SUBJECT: Forwards open items from Structural Engineering Branch
 811005-08 meeting in Woodbury, NY.

Subject: NUCLEAR PROJECT NO. 2
OPEN ITEMS FROM SEB MEETING

Attached are sixty copies of the open items from the Structural Engineering Branch meeting held in Woodbury, New York, October 5 - 8, 1981.

WNP-2
NRC-SEB MEETING

Figure 5.1-1 of DAR Rev. 2 will be revised. The building and hydrodynamic models used in the analysis are shown in References 130.067.1 and 130.067.2 (copies of the figures 130.067-1 and 130.067-2 are attached). The fluid masses were accounted for as explained in the same references.

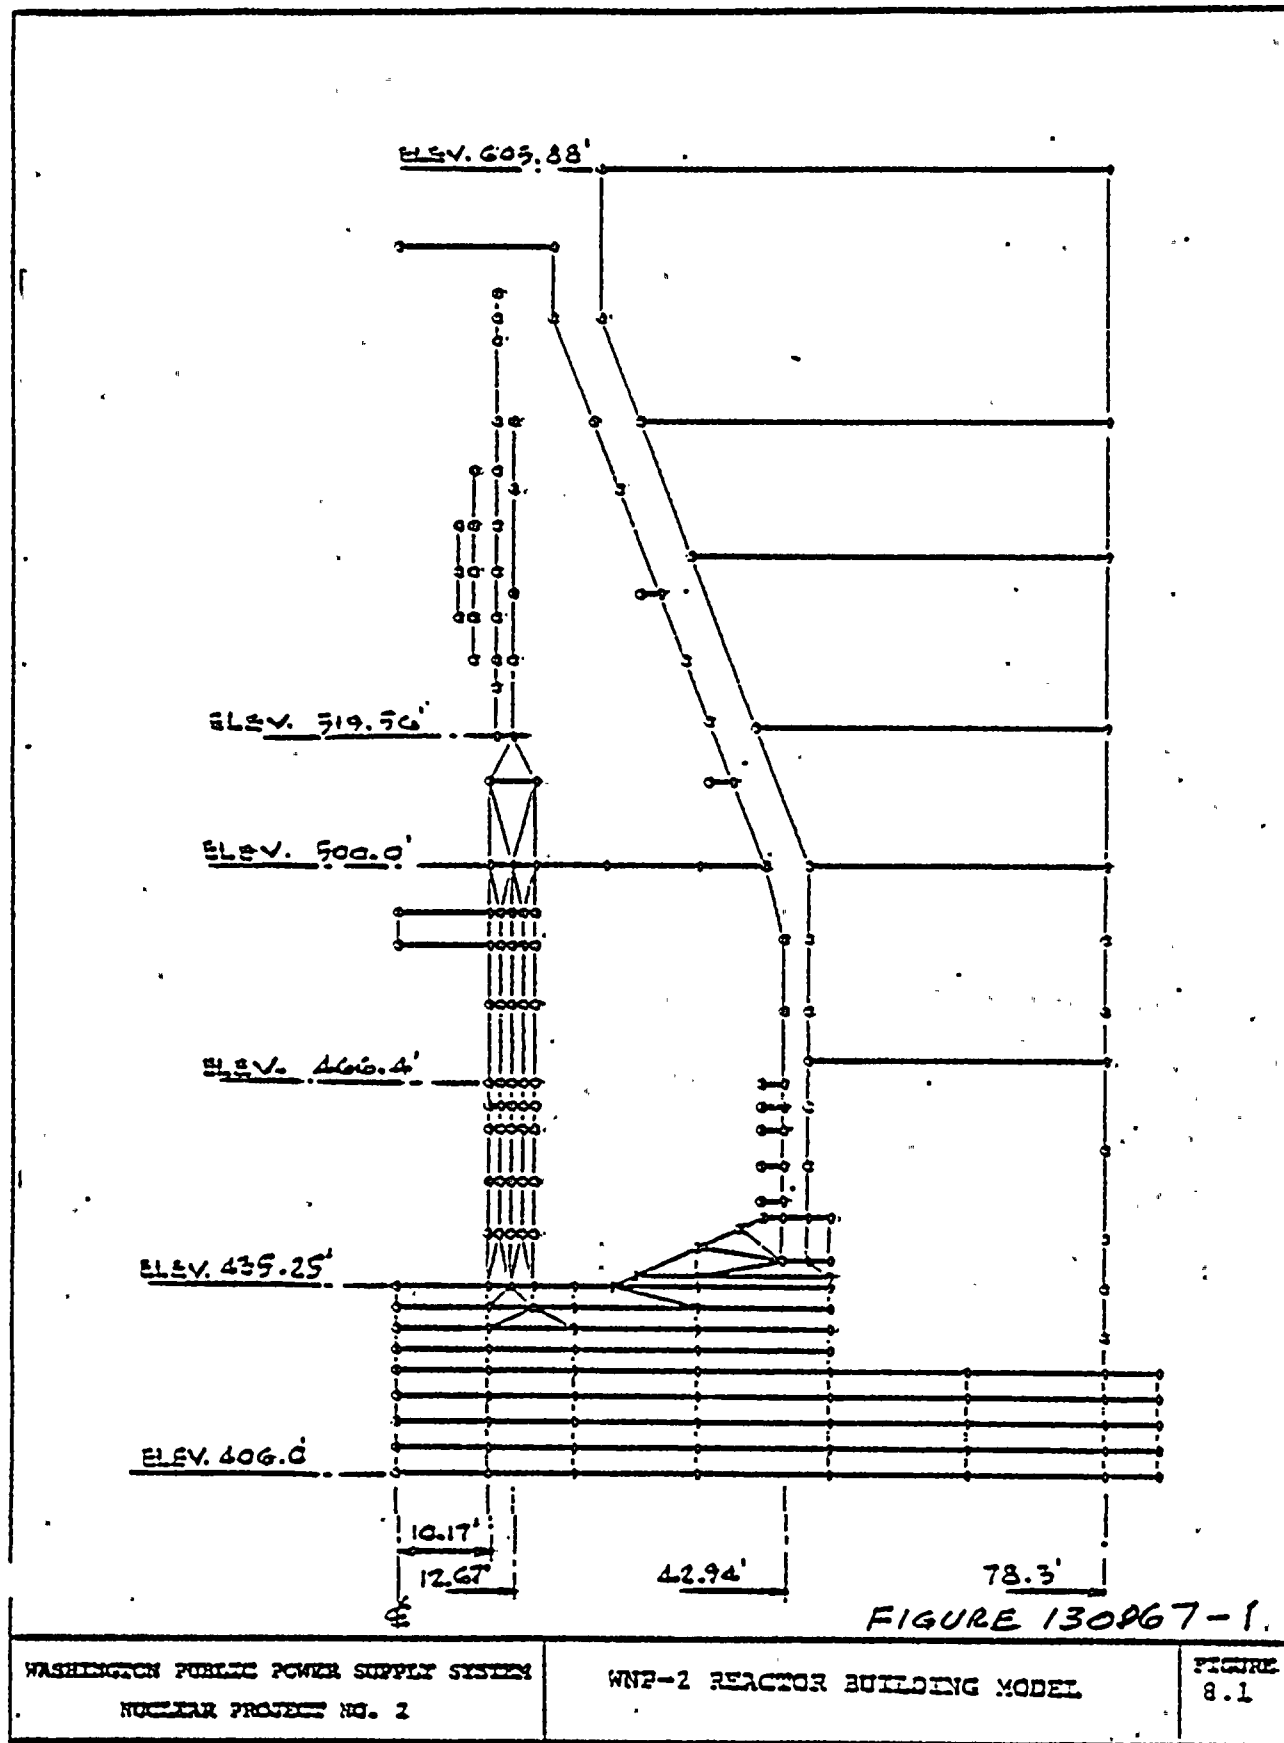
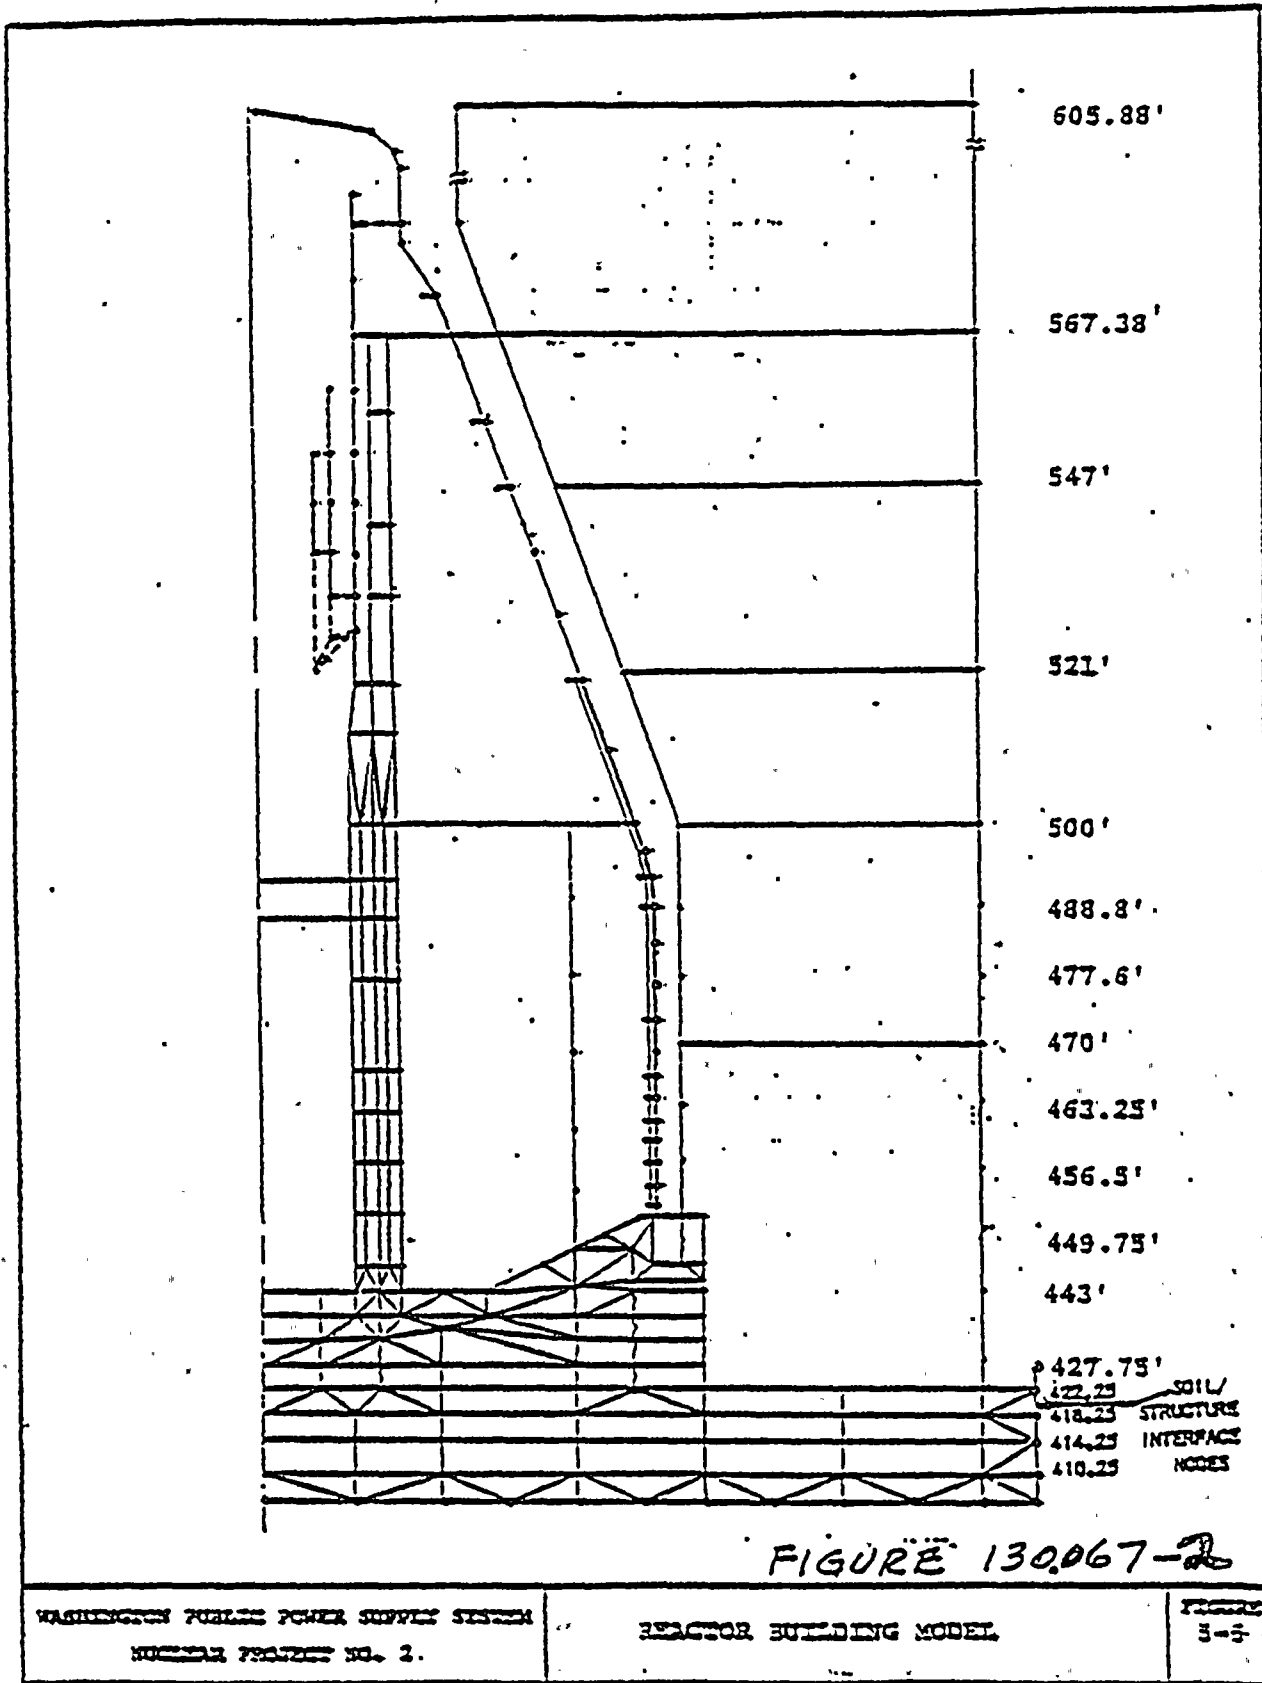
In Section 4.1.1.4.1, it is stated that for assessing the stresses in the containment shell due to chugging, building model in Chapter 5 is used. It appears that the building model shown in Fig. 5.1-1 does not contain the fluid. Indicate that with such a mathematical model how the fluid shell structure interaction can be considered. Furthermore, the bottom part of the model appears to be different from the actual. Explain this model discrepancy or provide justification for the discrepancy.

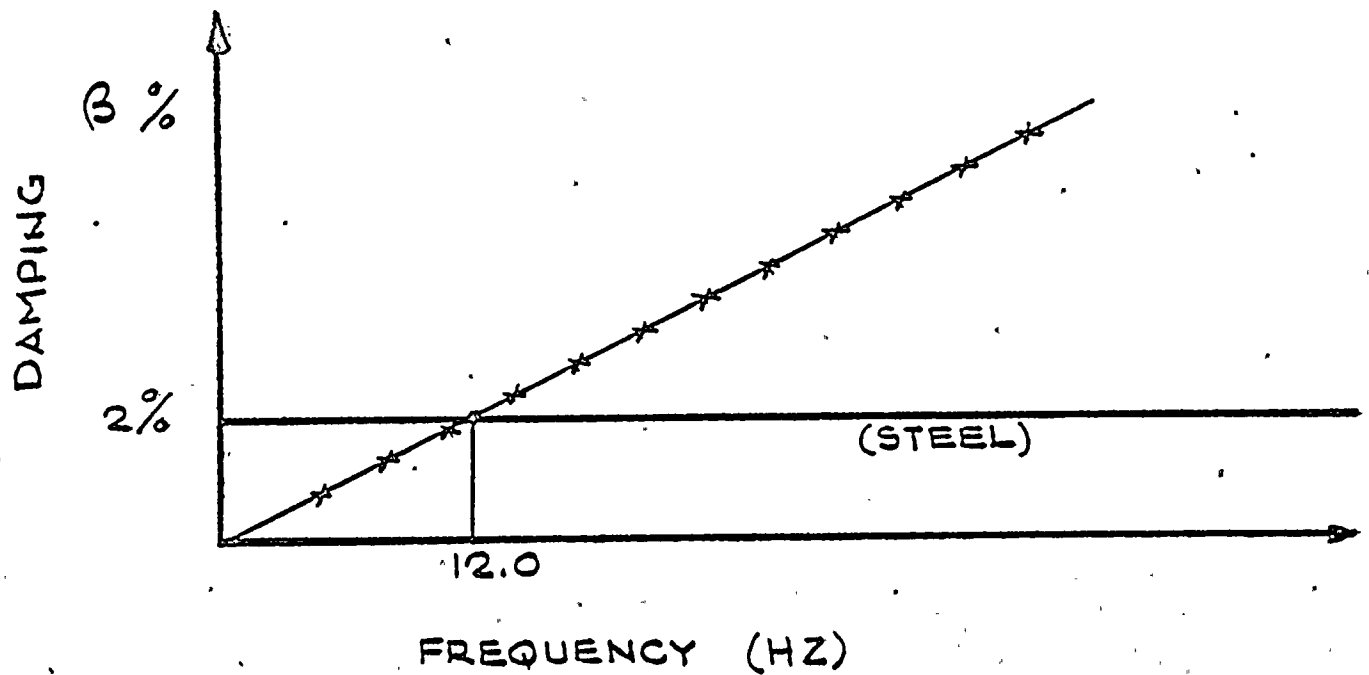
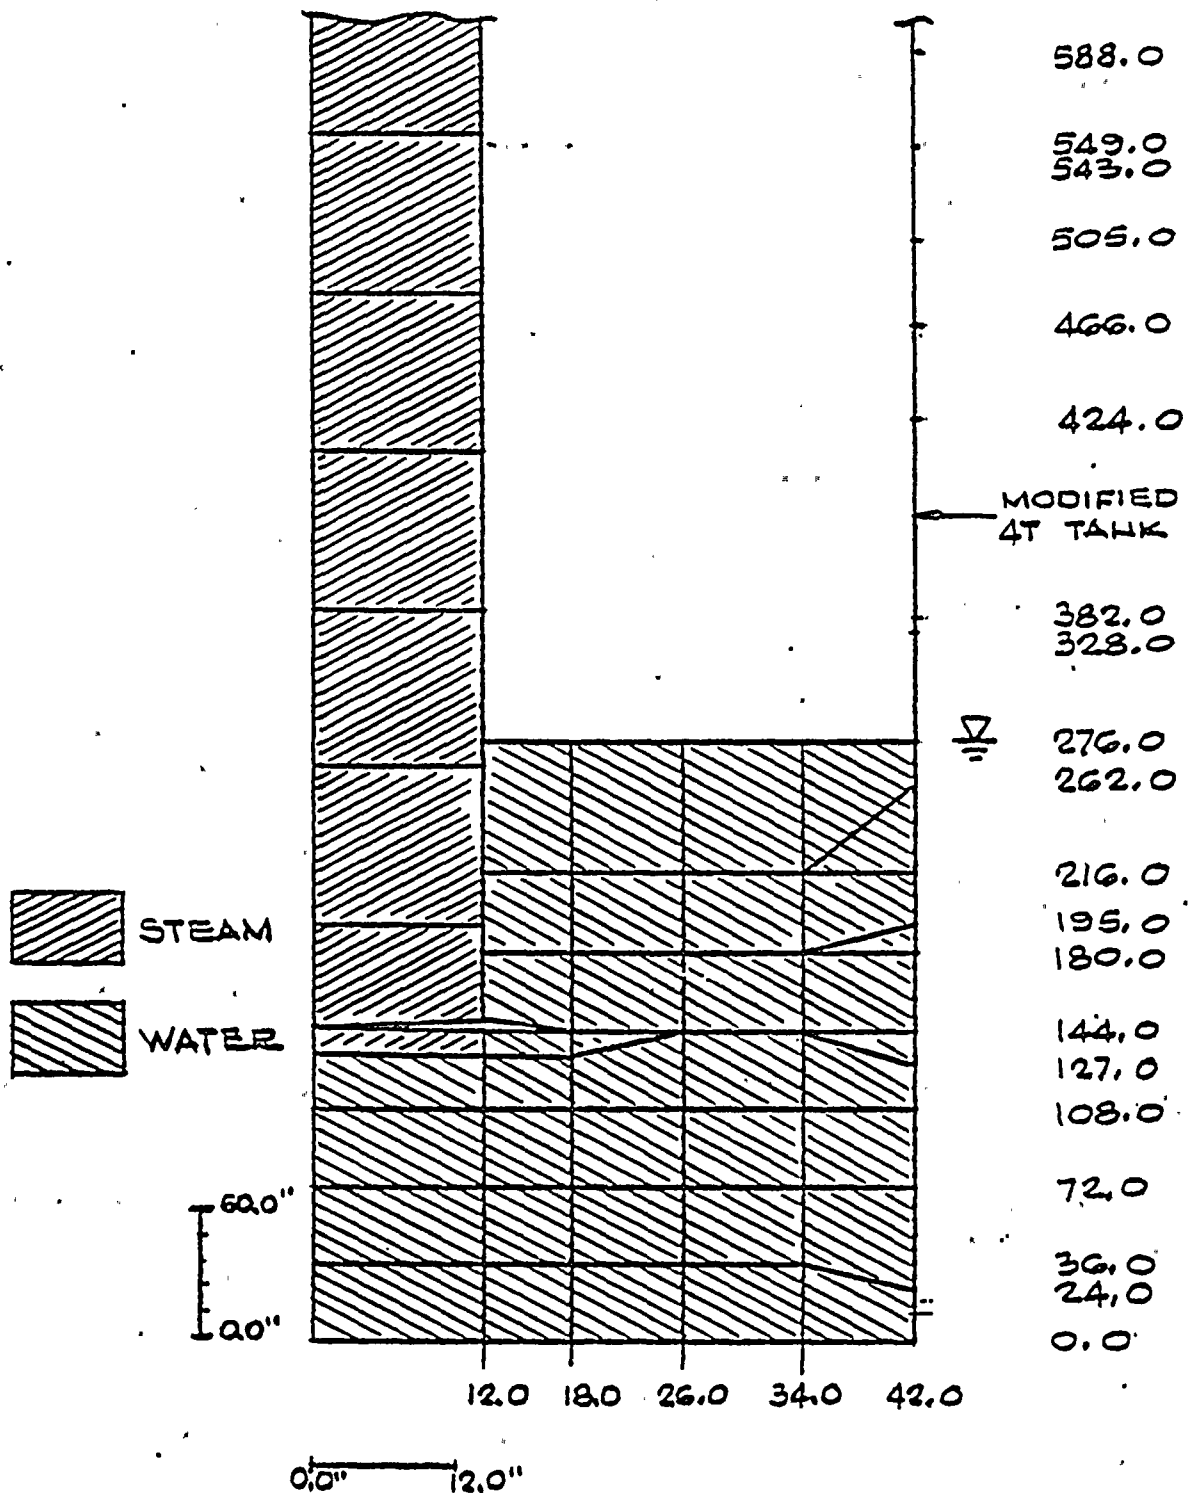
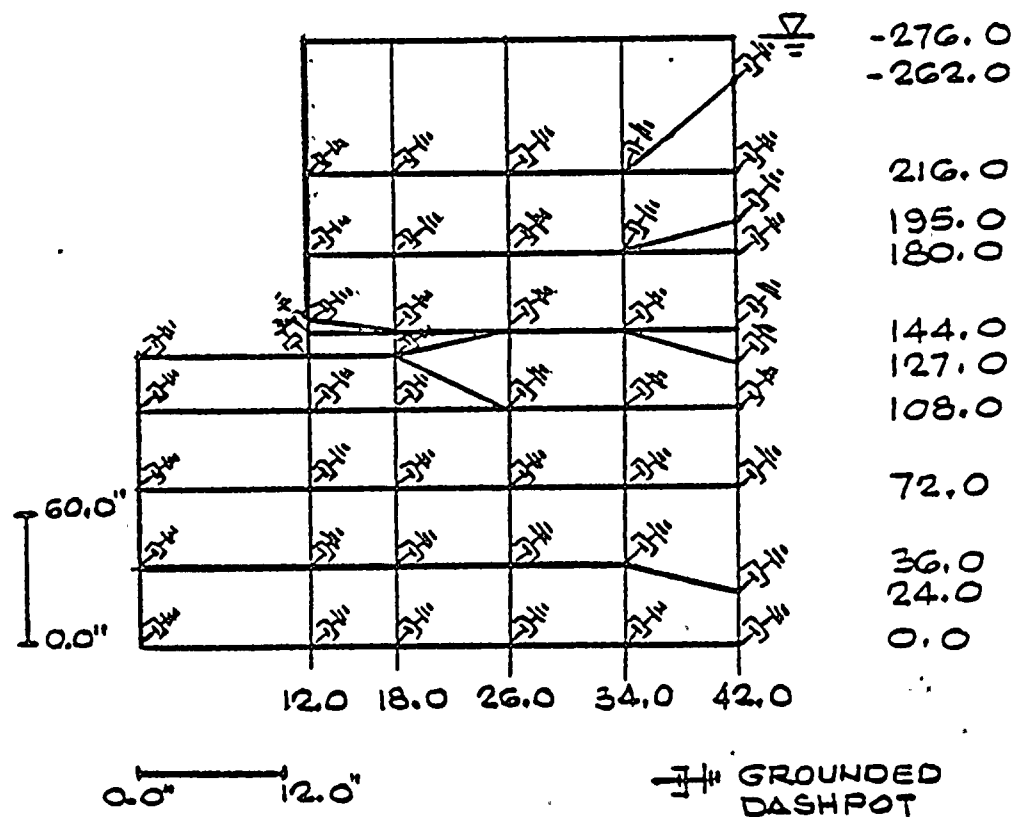
It is noted in Section 3.3.3 on Page 32 of the above referenced report, that viscous damping coefficients D_w and D_s are represented in the form of dashpots connecting the water elements and steam elements respectively. However, in the model shown in Figure 3-17a there is no identification of water or steam elements not is there any representation of viscous damping in the form of dashpots. Provide in a figure a model incorporating the various elements as described. In your evaluation of D_w and D_s by a trial and error method, how the effects of the structural damping of the tank can be isolated? Are the damping values thus determined considered in the theoretical formulation of the fluid-structure interaction analysis as discussed in the following question? How are they considered?

The structural damping in the 4T tank finite elements model is of Rayleigh type which increases linearly with the frequency of excitation, Fig. 130.072-1. A 2% critical damping value at 12.0 Hz was used for the structural steel elements. The 12.0 Hz was chosen since it is lower than the fluid-structure interaction frequencies observed in the tests. The structural steel damping, on the other hand, of the WNP-2 finite element model was chosen to be 2% at all frequencies (4% for concrete), as shown in the next question. The damping properties in steam and water were similar in both models. This way of treating damping in the two models insures conservatism of the results since:

- i. The calculated response of the 4T model is lower in the higher frequency zone, since the structural damping is more than 2%.
- ii. This means that the seven chugging sources that were evaluated in the B&R chugging report are conservative at frequencies higher than 12Hz, since the calculated responses of these sources were required to envelope the test results at all frequencies.
- iii. Since the damping properties of the steam and fluid were kept constant during the sources evaluation phase (4T tank model) and the sources application phase (WNP-2 model), and since during the calculation of the WNP-2 responses, both the applied chugging sources and the structural damping were conservative, it is concluded

that the calculated WNP-2 responses to chugging
load are conservative.
